RESULTS FROM ONLINE FORUM – HAVE YOUR SAY
Project: New Masterplan for Marina Reserve, St Kilda

All comments received up until 15 September 2011.

St Kilda Marina Reserve Skateable Space Design Comments

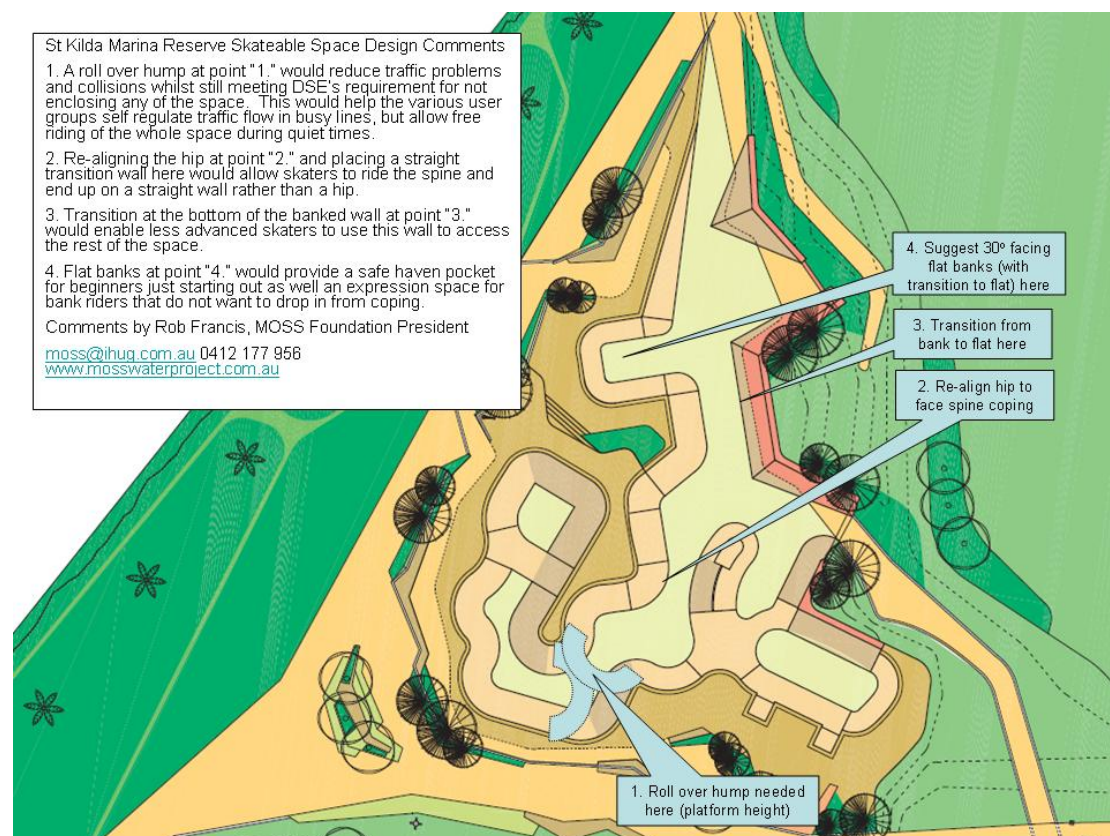
1. A roll over hump at point "1." on the attached plan would reduce traffic problems and collisions whilst still meeting DSE's requirement for not enclosing any of the space. This would help the various user groups self regulate traffic flow in busy lines, but allow free riding of the whole space during quiet times.
2. Re-aligning the hip at point "2." and placing a straight transition wall here would allow skaters to ride the spine and end up on a straight wall rather than a hip.
3. Transition at the bottom of the banked wall at point "3." would enable less advanced skaters to use this wall to access the rest of the space.
4. Flat banks at point "4." would provide a safe haven pocket for beginners just starting out as well an expression space for bank riders that do not want to drop in from coping.
